## **EGT turbocharger Napier Na 355**

# SERVICE BULLETIN

Ref. No. Small NA Series / 14  
Issued by. P. D. Pearce  
User Support Services.  
Date. 3. 07. 95  
No. of Sheets. 3  
Sheet No. 1

**SUBJECT :- NA-355 TURBOCHARGER – NOZZLE SETSCREW BREAKAGES.**

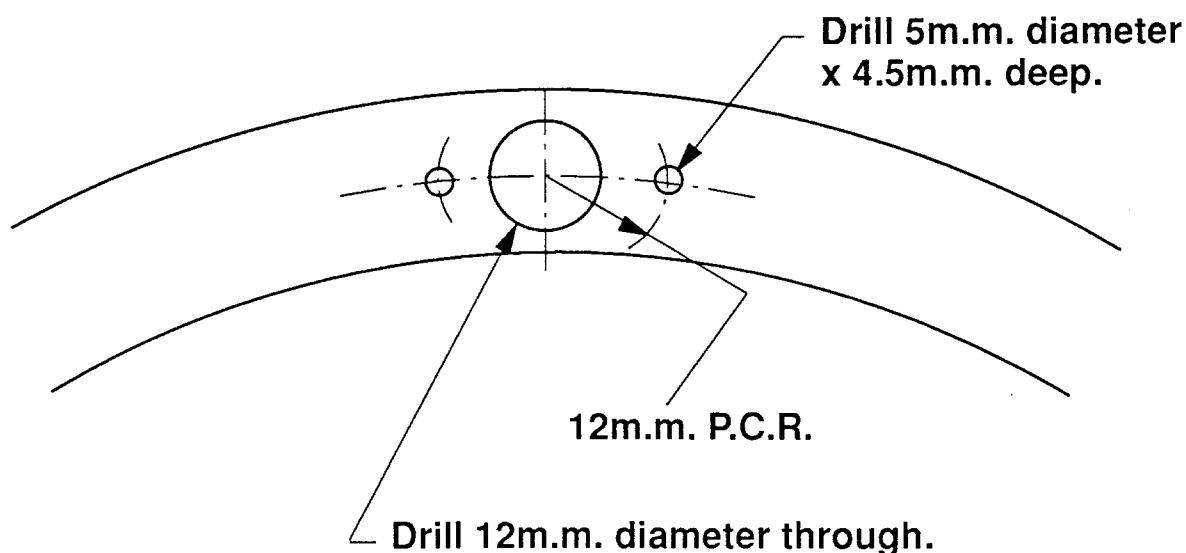
## **A. RE-DRILLING AND TAPPING OF THE TURBINE INLET CASING.**

The nozzle setscrews (9 off) are drilled on a pitch circle diameter of 210 m.m. and are equally spaced.

In most instances the locating holes are drilled and tapped through the nozzle clamping face, However there are casings which have blind holes. (i.e. not drilled through). The following instructions therefore apply.

The drilling and tapping should not break through the internal cast bosses which support the tappets.

Drill 8.5 mm diameter x 15 mm deep hole in the nozzle clamping face.

Tap M10 x 1.5 mm pitch x 12 mm.

### **C. MODIFICATION OF THE NOZZLE INNER RING**

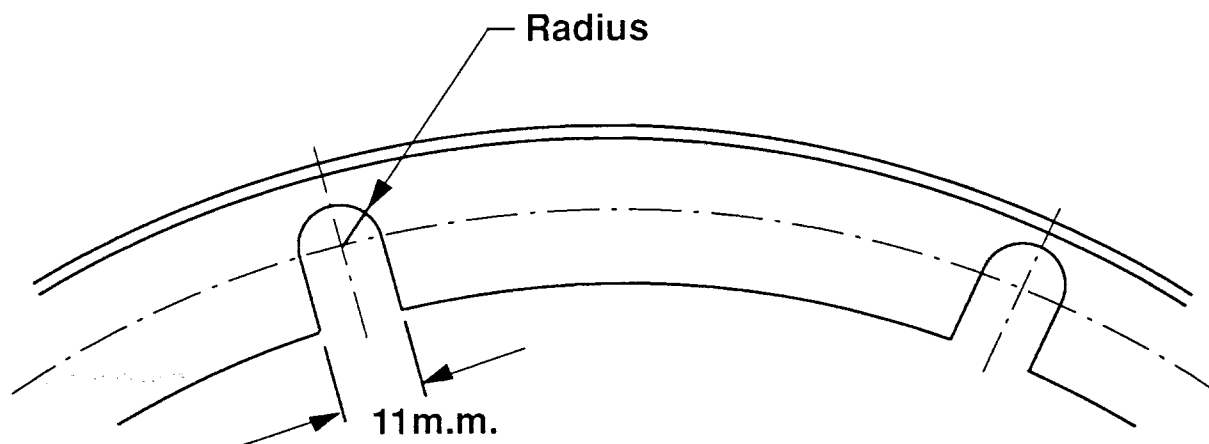
The modification of the nozzle involves enlarging nine retaining slots to accommodate the larger fixing screws. Increase the size of the existing slots to the width shown below. Maintain positional tolerance by removing metal equally (1m.m.) from each side of the slot.

**De-burr and remove sharp edges as necessary**
